CHANGE: REMARK 4 ADDED

INITIAL CLIMB PROCEDURES	RWY 01 Cat A/B/C	BOLZANO
		TRANSITION ALT 10000

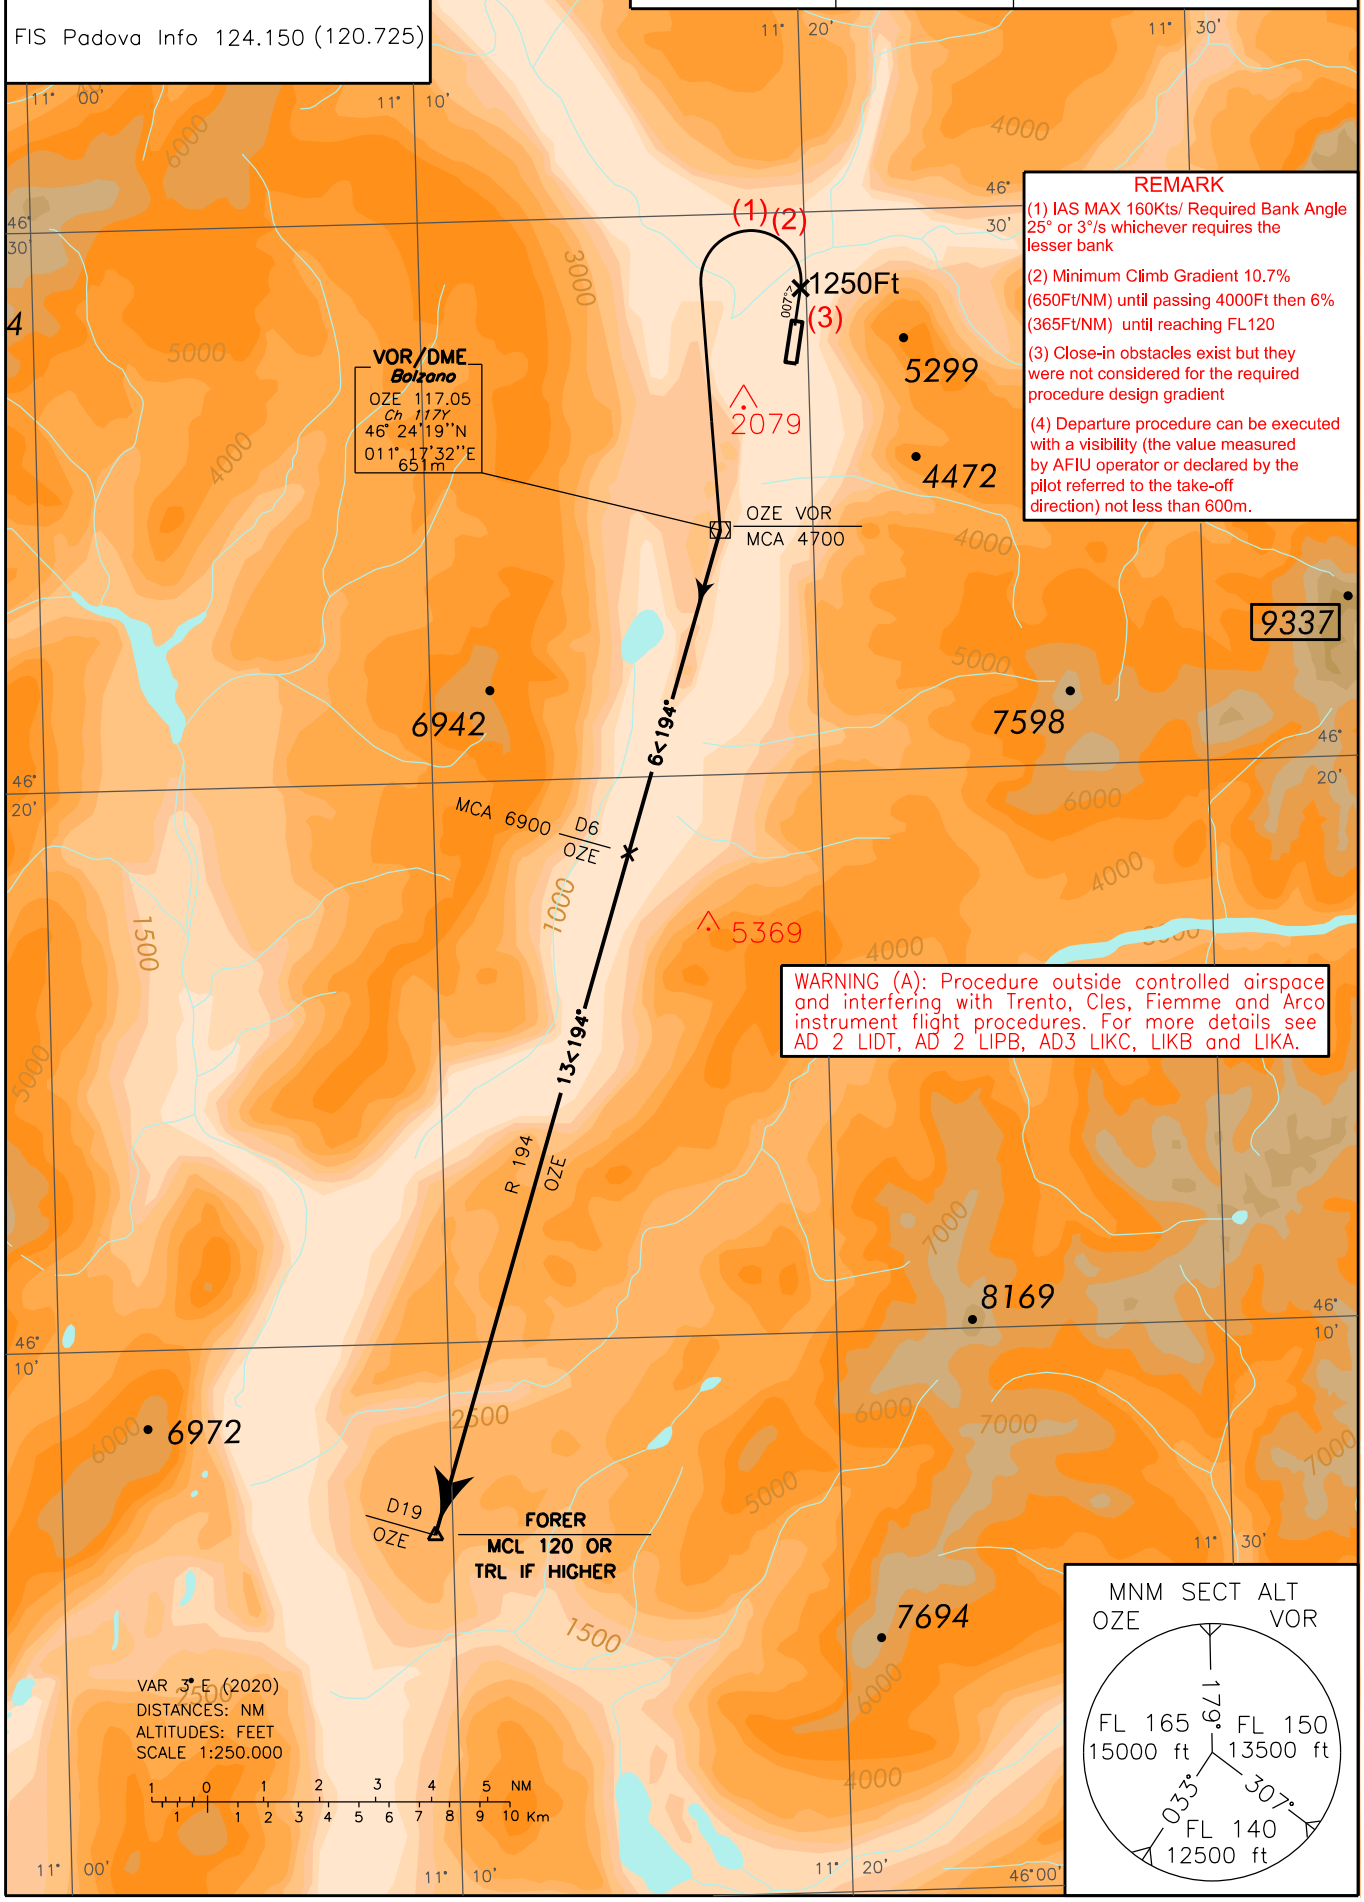
(4) Departure procedure can be executed with a visibility (the value measured by AFIU operator or declared by the pilot referred to the take-off direction) not less than 600m.
